# PROVIDENCE POINTE

Mecklenburg County, North Carolina

**CHARLOTTE-MECKLENBURG  
PLANNING COMMISSION**

SUBJECT: Administrative Approval for Petition No. 94-18, Daniel L. and Carolyn S. Kennedy.

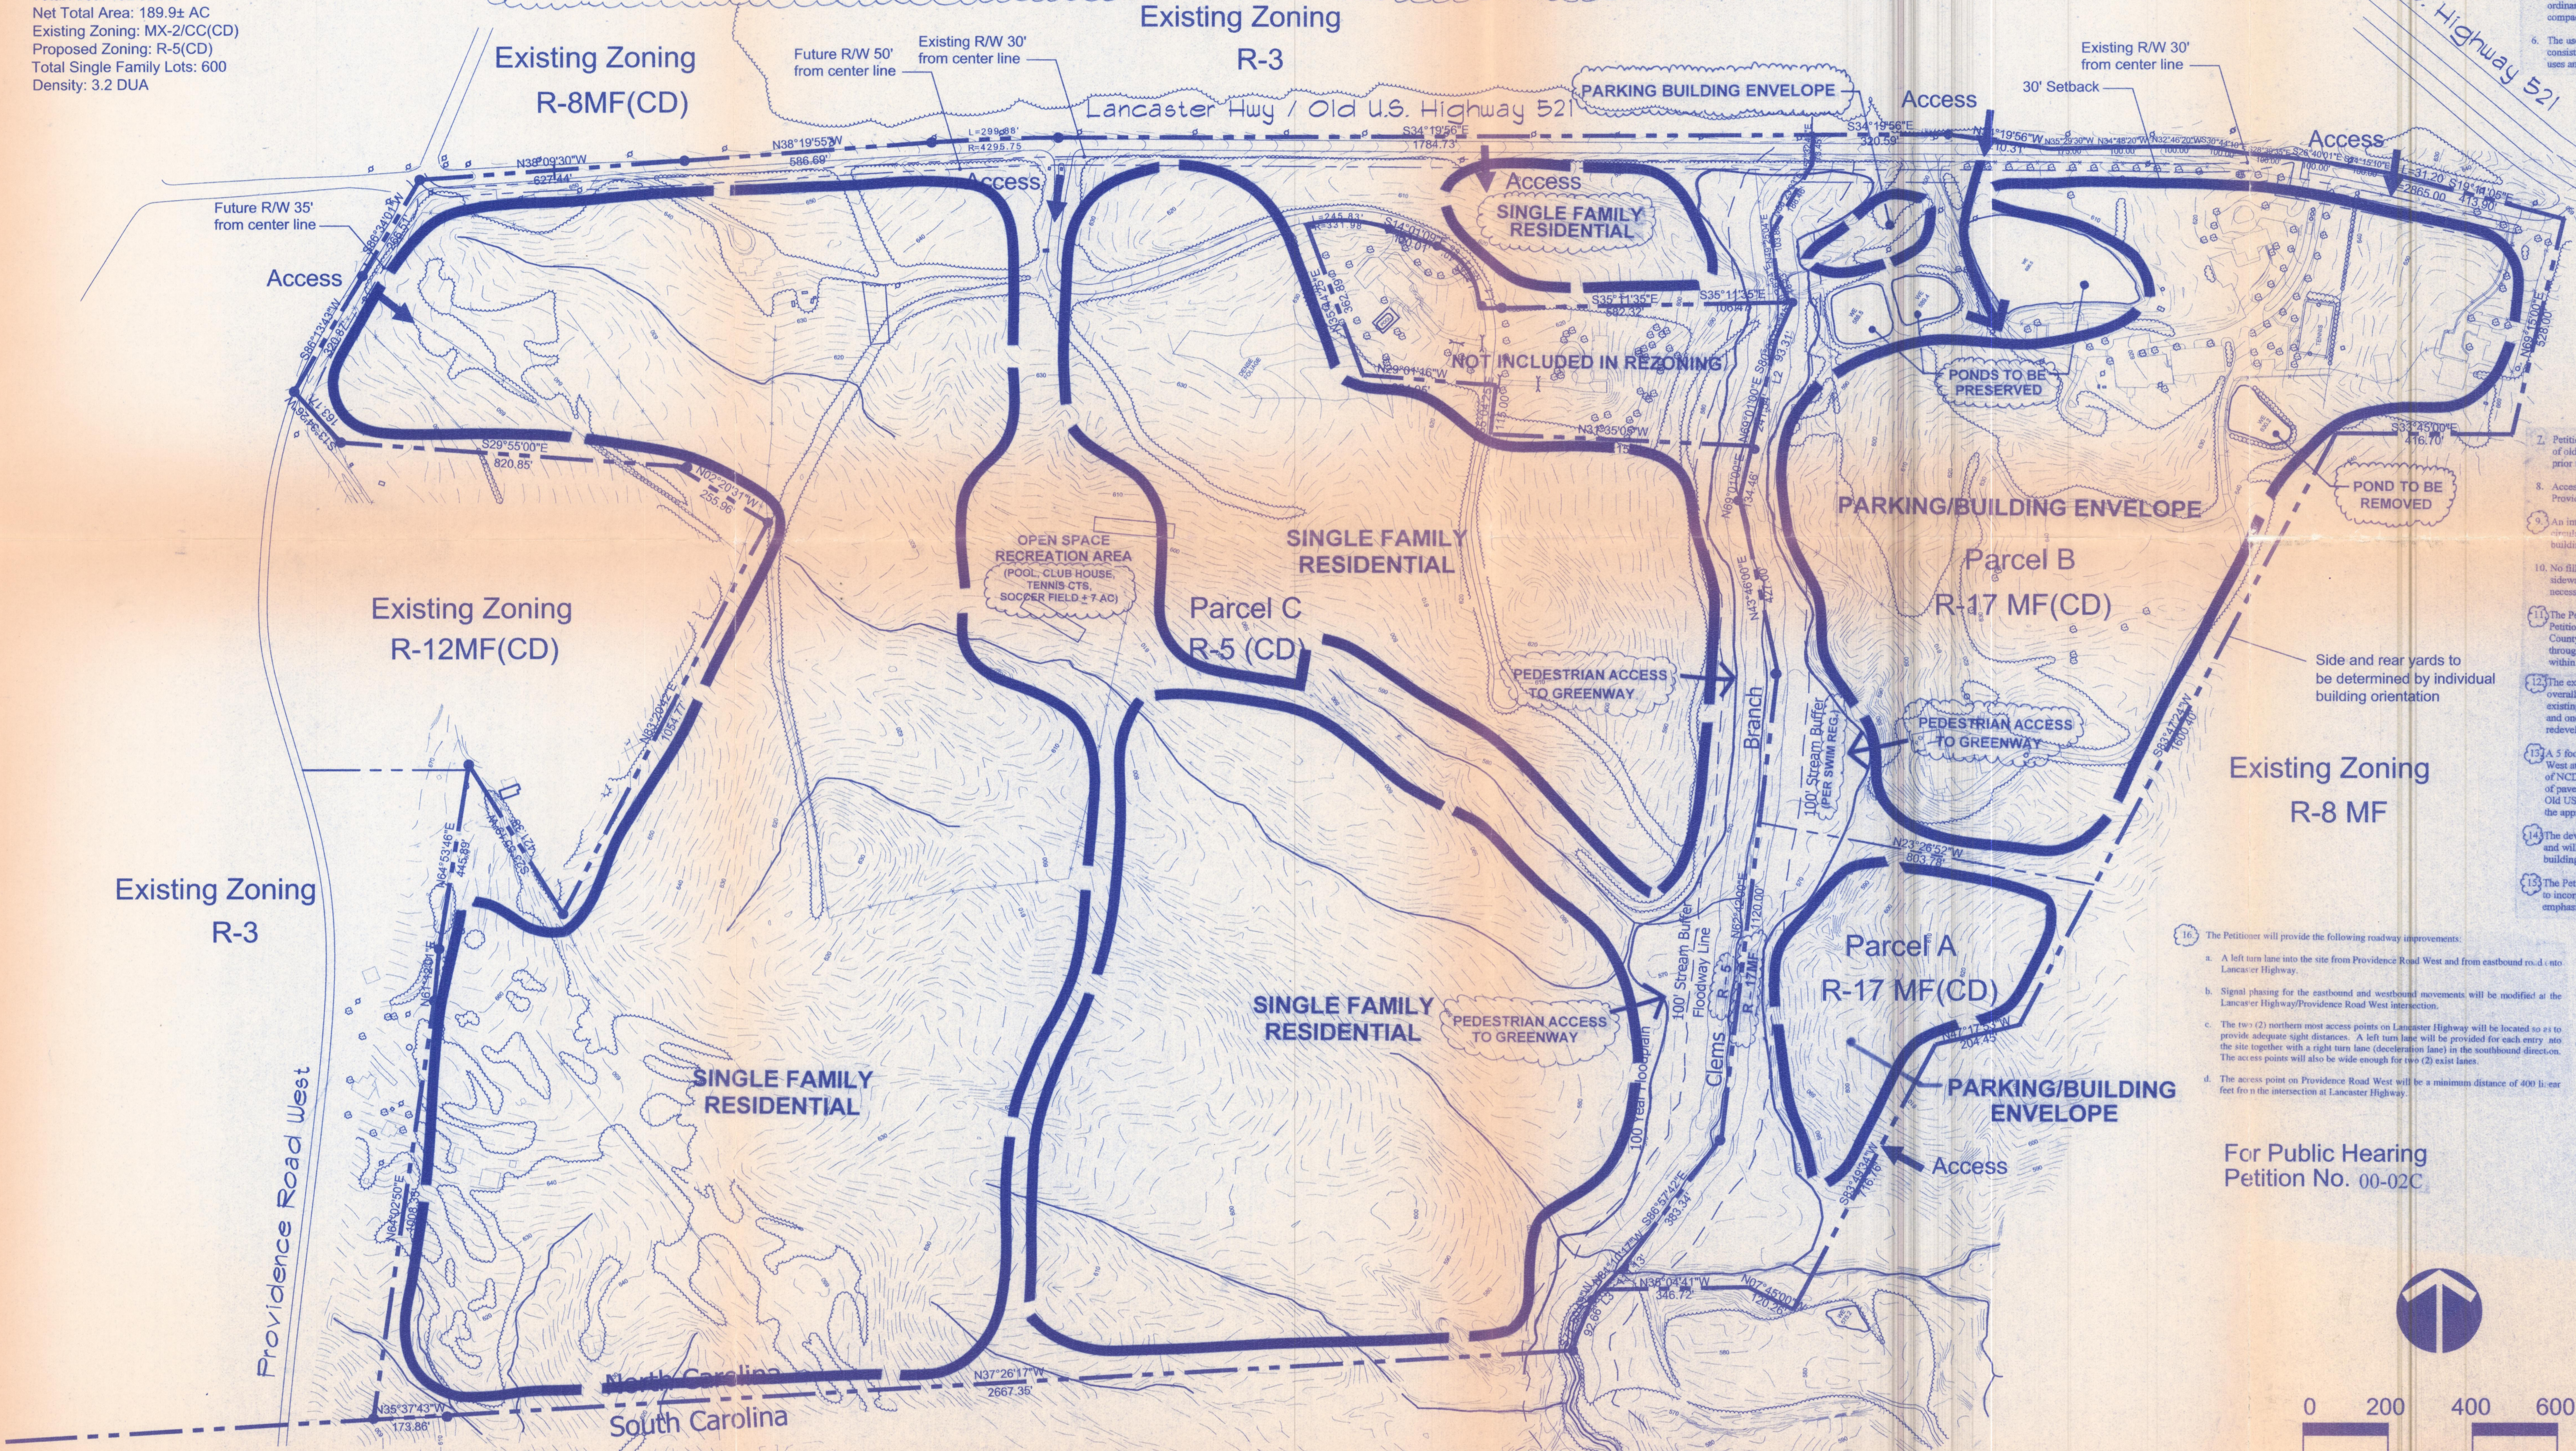
Attached is a revised technical data sheet for the above referenced petition. The plan has been revised to remove a reference to a S.W.I.M. buffer on a creek branch to the north of Clems Branch. It has been determined that this buffer is not required. Since this change is minor, I am administratively approving this request. Please use this revised plan when evaluating requests for building permits and certificates of occupancy.

DATE: October 25, 1999  
PROJECT NO: 1099079  
REVISIONS: 12/27/99: REVISIONS PER PLANNING COMMISSION  
2/2/00: REVISIONS PER ZONING COM. APPROVAL  
2/21/01: REMOVE 50' SWIM BUFFER
